Thor Motor Coach Recall Repair Instructions

Recall #	20V-498 2020-389		
Description/Title:	Firefly G9		
Affected Product Line(s):	Certain model year 2019-2021 Hurricane & Windsport motorhomes		
Service Campaign # :	RC000203	Released Date:	10/20/2020
Repair Code:	Model years 2019 & 2019.5 TMCRC80494V Model years 2020 & 2021 TMCRC80495V	Document Date:	10/20/2020
Time Allowed:	Model years 2019 & 2019.5 0.5 Model years 2020 & 2021 0.4	Document Revision:	A

G9 Protection Module – Installation Instructions

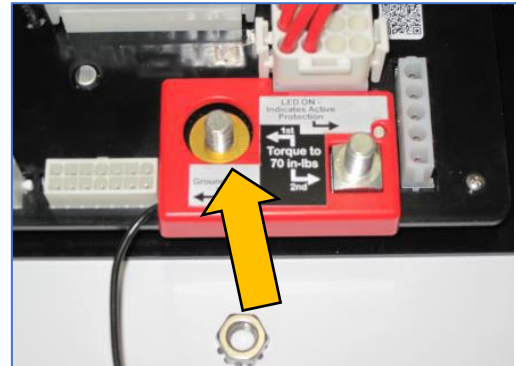
(3.2) Remove the external tooth washer nut and existing power cable from the G9 ECM power input stud.

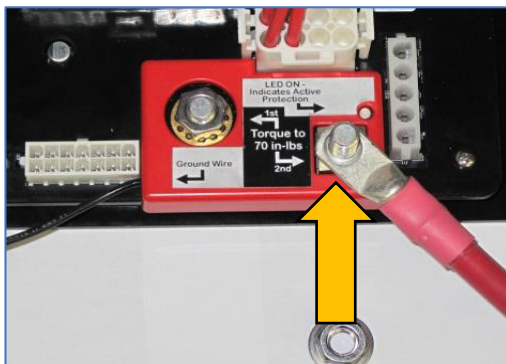
(3.3) Attach G9 Protection Module onto the G9 Power Stud with external tooth washer nut and torque to 70 in/lbs.

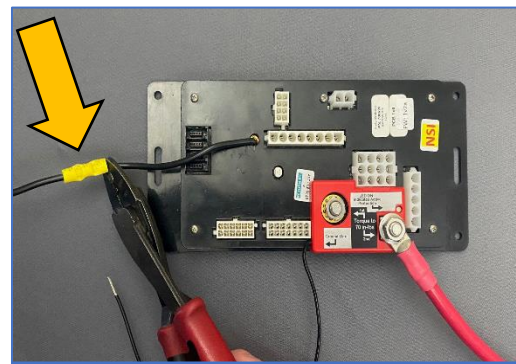
(3.4) Install power cable onto G9 Protection Module stud with provided nut and torque to 70 in/lbs.

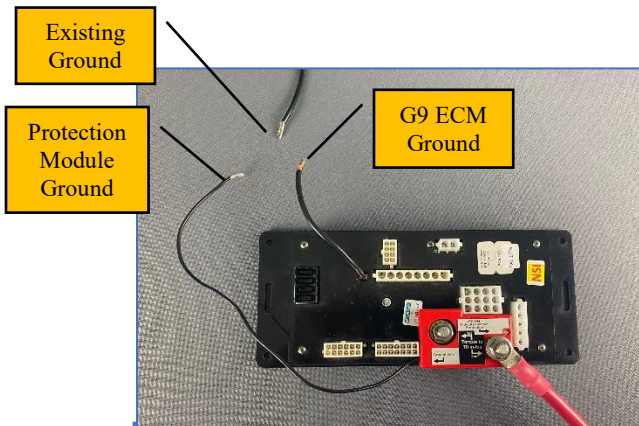
(3.5) Locate existing G9 ground wire connection and disconnect or cut wire.

(3.6) Strip each ground wire at least 10mm and splice the G9 ECM Ground, the Protection Module Ground and the Existing Ground wire together with provided yellow wire nut.

(3.7) Turn on Main Power Switch and verify that the LED illuminates.

2019 AND 2019.5 UNITS

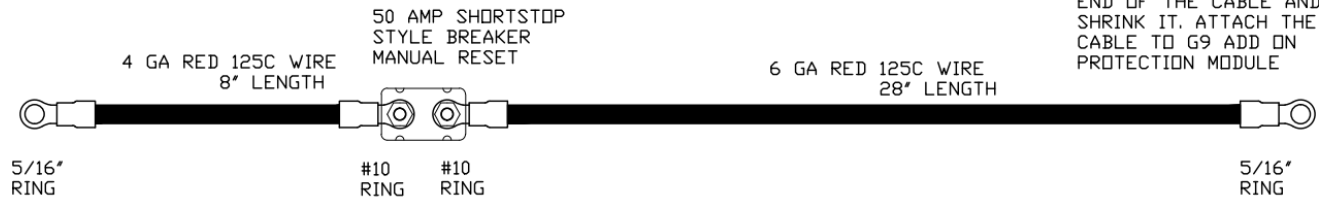
REMOVE 5/16" NUT FROM DISCONNECT TERMINAL THAT HAS THE 6 GA RED WIRE FROM BATTERY DISCONNECT TO G9 BOARD. ADD THIS CABLE AND REPLACE THE NUT

REMOVE THE RED 6 GA. CABLE FROM THE G9 BOARD. CUT THE TERMINAL OFF AND APPLY THE INCLUDED HEATSHRINK OVER THE CUT END OF THE CABLE AND HEAT SHRINK IT. ATTACH THE NEW CABLE TO G9 ADD ON PROTECTION MODULE
